**BOARD ACTION REPORT – APPEALABLE ITEM**

**Project Name:** 143 S Swinton Avenue  
**Project Location:** 143 S Swinton Avenue  
**Request:** Class V Site Plan, Landscape Plan, Elevations, Certificate of Appropriateness (2018-155), and Variance (2018-156)  
**Board:** Historic Preservation Board  
**Meeting Date:** February 6, 2019

## STAFF REPORT

**ITEM:** 143 S. Swinton Avenue, Old School Square Historic District – Class V Site Plan, Landscape Plan, Elevations, Certificate of Appropriateness (2018-155), Waiver, and Variance (2018-156) for addition and conversion of the existing single-family residence to office .

WEST ELEVATION MASSING DIAGRAM - SWINTON AVENUE

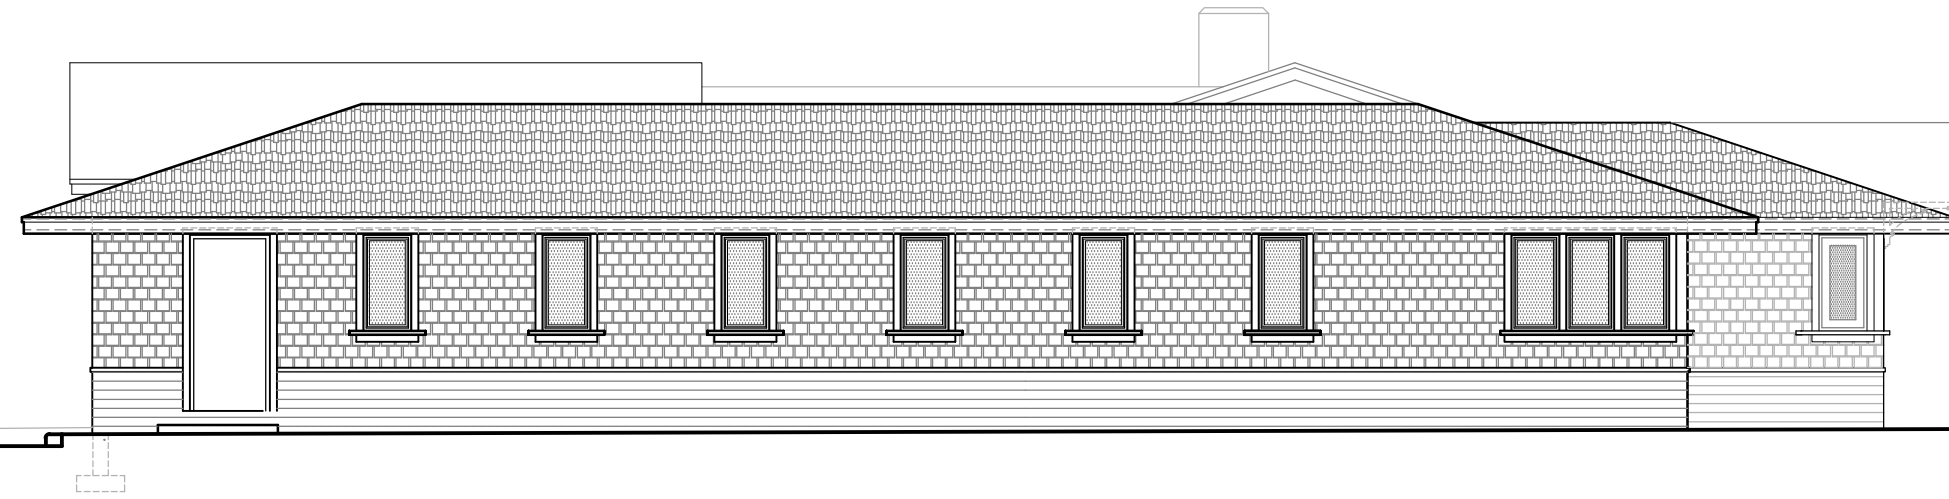
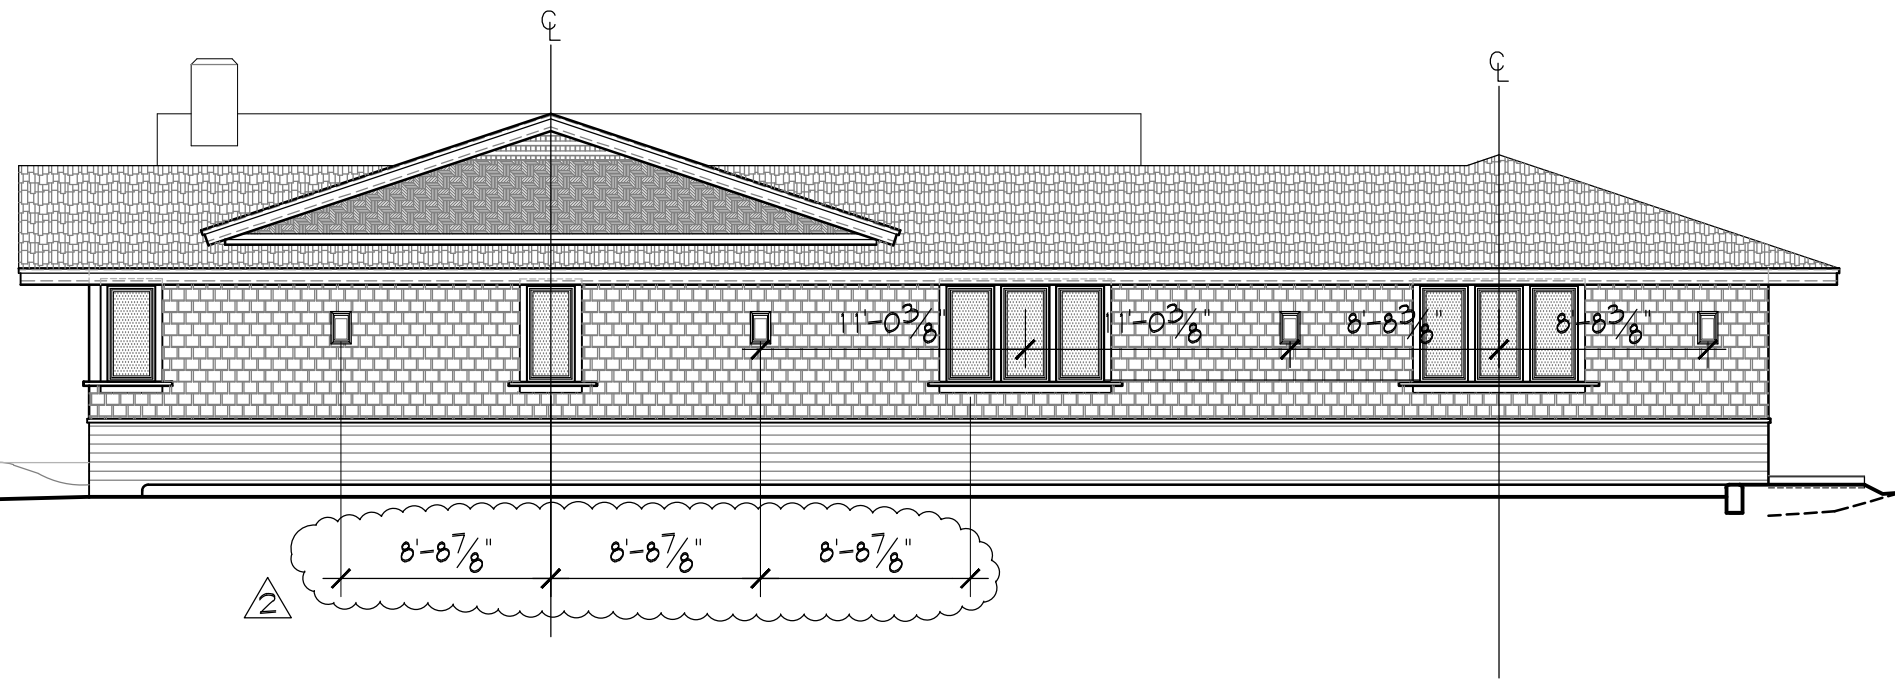
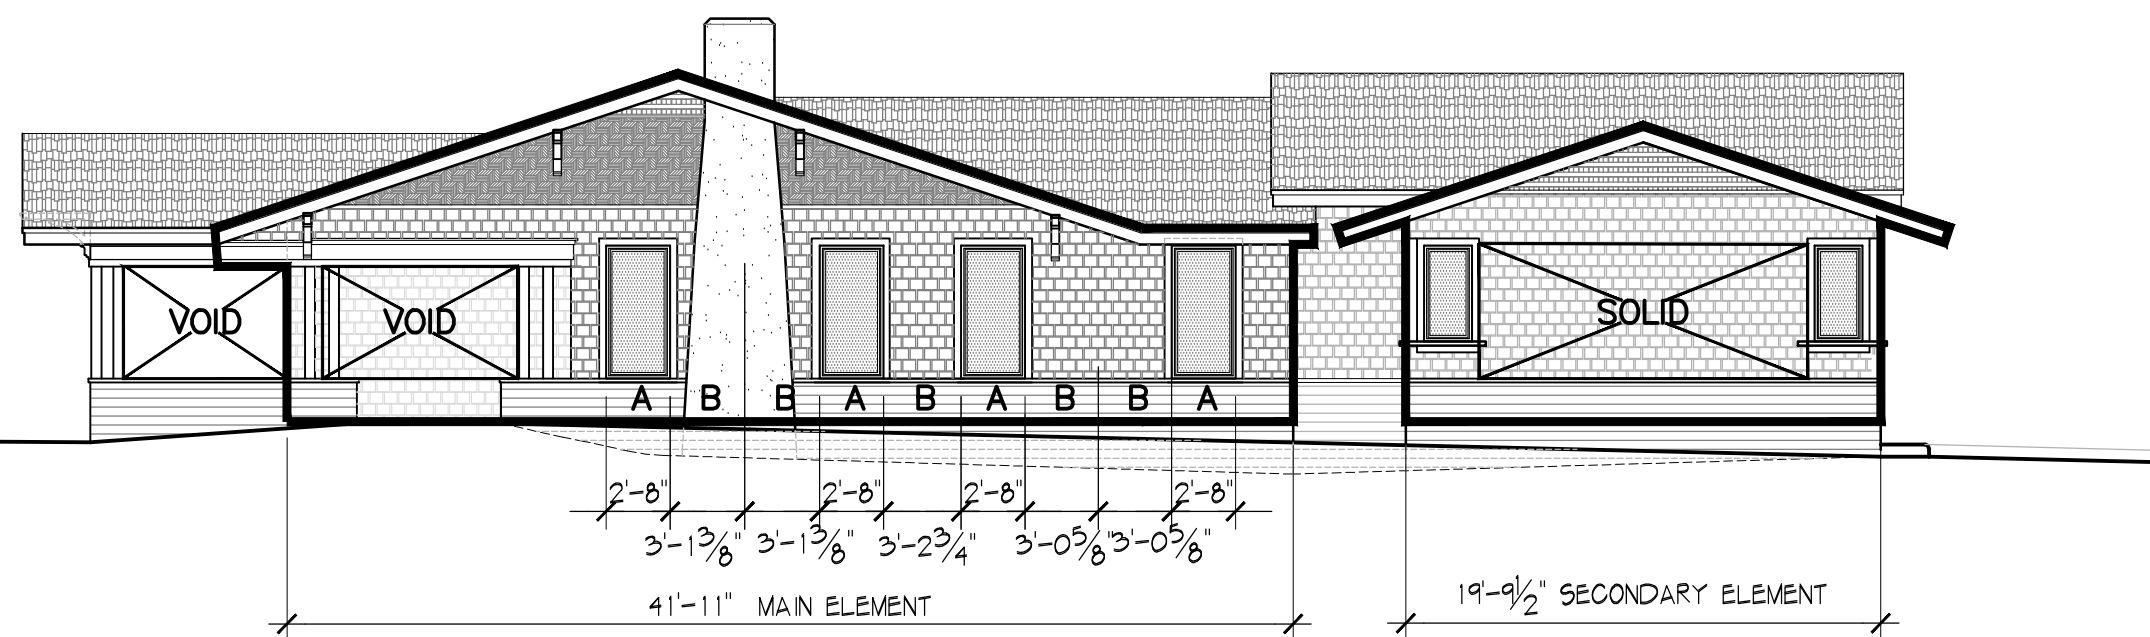
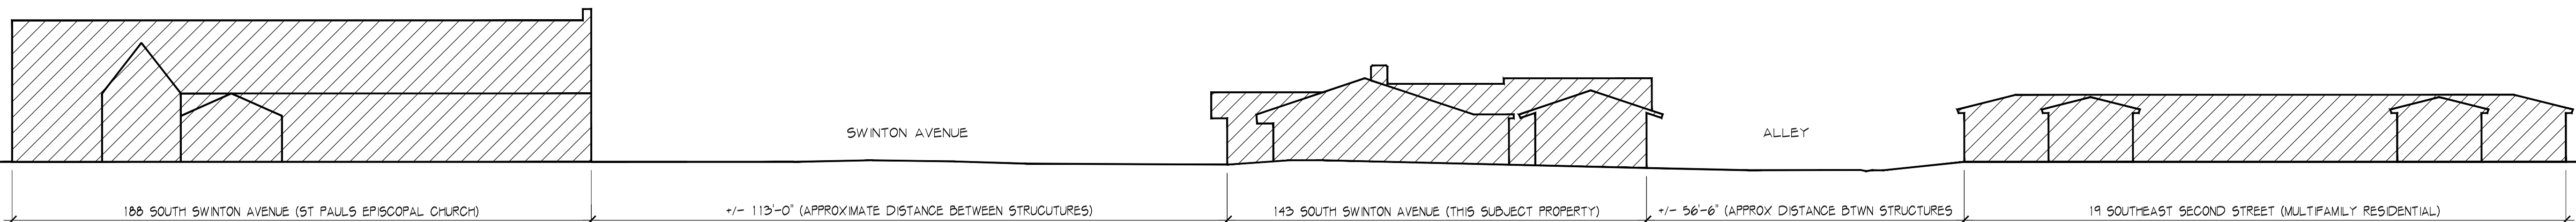
Recommended denial to the City Commission for the Waiver request to allow the maximum length of building fronting a street to exceed 60 feet for a total of 63.5' facing Swinton Avenue for the property located at 143 S. Swinton Avenue, Old School Square Historic District, by finding that the request is inconsistent with the criteria set forth in the Land Development Regulations Section 2.4.7(B)(5), on a 6 to 0 vote (Bright absent).

*Even though the (2) proposed building facades in question exceed the Max width of 60 feet; please note that the portions of these new additions (to the north of the west façade and to the east of the south façade) are not only proportional to the main existing façade, in terms of height, scale and massing, but also proportional in that the new additions are in a proper scale/mass in order to serve as 'a secondary and subordinate structure to the main mass of the historic building and do not overwhelm the original building – 4.5.1(E)(8)(m)(6); thereby keeping the intent of the code.*

- a) Renovation to revert the existing SW corner of the historic home back to its original 'exterior porch' in order to not only improve the historic preservation of the property but also to provide some voids in the overall building facade to diminish the appearance of the length of the building as well as to improve the aesthetics of the existing structure. This new 'void' encompasses 20'-0" of the existing 50'-0" South Façade and is 18'-0" of the existing 37'-0" West Façade, thereby by providing much visual relief or void to the overall length of the building.*

- b) We have designed two short jogs in the exterior walls (along the West façade) and one short jog in the exterior wall (along the South Façade) where the new structure is 'joining' into the existing. These jogs are proposed to not only enhance the aesthetic appeal (NOT make it appear as an obvious addition) but also to provide a feasible structural expansion joint to tie the new into the old. These jogs provide further 'visual relief' to the proposed overall length of these facades that exceed 60'-0"; however still meet the intent of the code.*
